**Responses to Significant Comments on the Designation  
Recommendations for the 2010 Sulfur Dioxide National Ambient  
Air Quality Standards (NAAQS) – Supplement for Four Areas in  
Texas Not Addressed in June 30, 2016, Version**

Docket Number EPA–HQ–OAR–2014–0464  
U.S. Environmental Protection Agency

November 29, 2016

Figure 1. Overall good agreement for all hours by AERMOD for the Shotts Monitor

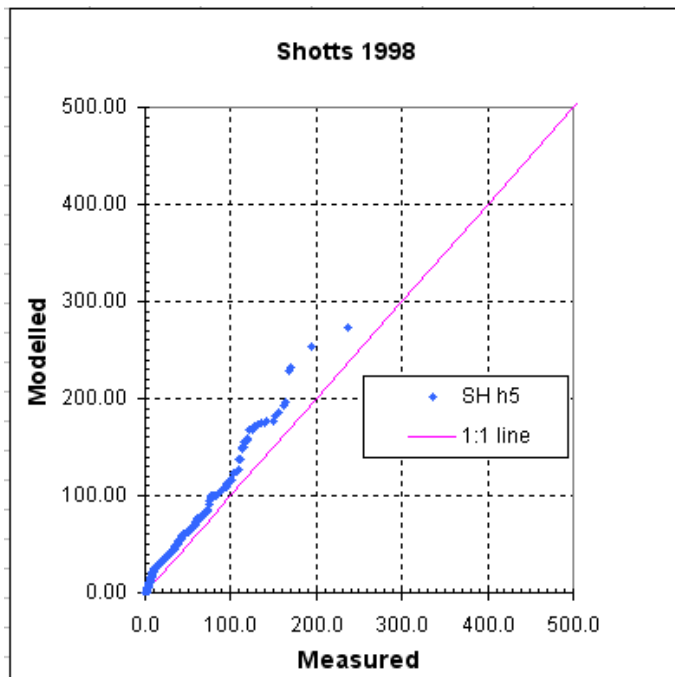
- ***Sub-Comment 9.2:*** According to a commenter (Luminant), the AERMOD model mishandles a penetrated plume causing overestimates of 50%. Luminant asserted that their Analysis of enhanced AERMOD debugging output confirmed that peak concentrations predicted by Sierra Club's modeling are caused by the failure to properly simulate a penetrated plume. Luminant used this 50% discount approach in manipulating Sierra Club's proposed modeling information to calculate a 2013-2015 DV for their Big Brown and Martin Lake facilities.

In support of this comment a reference was provided to a presentation<sup>2</sup>. Though not a peer-reviewed publication, the presentation was reviewed for relevancy to the current regulatory use of AERMOD. The supplied reference presentation cited an additional presentation which was also examined.

EPA reviewed the sub-referenced presentation<sup>3</sup> in which a case was made for the over-prediction of concentrations by AERMOD during dispersion of a penetrated plume. This study involving three power plants' impacts on several monitors occurred in a complex airshed with sharp terrain relief. Such terrain likely affected dispersion from the power plants through effects such as enhancements of vertical mixing, channeling of flows, and divided flows that is not present for the Luminant plants in the relatively flat terrain of northeast Texas. Because of the complexity of the situation modeled in the study it is not clear whether the findings would apply to the Luminant plants - all of which are located in relatively flat terrain. Whether a finding of over-prediction of concentrations during this specific dispersion regime in this complex situation can be generalized to other locations is not known. However, the presentation indicates that *overall* the AERMOD estimations of ranked concentrations, even in this complex situation, are accurate. The correct conclusion relevant to the current use of AERMOD is that the model did an excellent job in estimating the ranked maximum concentrations at all locations where monitors were present. As stated in Paine et.al.<sup>4</sup> concerning the use of Q-Q plots:

The alternate DV calculations Luminant included that used Sierra Club's 2015 modeling for 2012-2014 is fundamentally flawed by their use of the 50% discounting factor. Luminant took 2012 maximum values and scaled the value down using a ratio of 2015 SO<sub>2</sub> emissions divided by 2012 SO<sub>2</sub> emissions (used the emission ratio times the 2012 Highest 4<sup>th</sup> High). Luminant then used this scaled 2015 estimate based on Sierra Club modeling results for 2012 to estimate a new DV using the 2013 and 2014 Sierra Club results to estimate an artificial DV value for 2013-2015 for Big Brown and Martin Lake. These values were above the NAAQS, so Luminant utilized their proposed 50% discounting factor to further adjust these back of the envelope type estimates. The use of the 50% discount factor is not appropriate and the unadjusted DV was above the standard for Big Brown and Martin Lake.

The commenter is also not considering that the same times that they have identified are some of the meteorological conditions that do result in higher ground level impacts. So to identify all of these occurrences using the debugging output tool blankets all such conditions as suspect, when in reality this is one of the types of meteorological/dispersion situations that leads to higher impacts that can impact the DV.

Furthermore, adjusting modeling results based on a one or two modeling scenario comparisons to a few monitors is not appropriate and such approaches of attempting to calibrate the model results are prohibited by the **Guideline on Air Quality Models {GAQM}** (40 CFR Part 51 App. W 7.2.9 Calibration of Models; November 9, 2005).
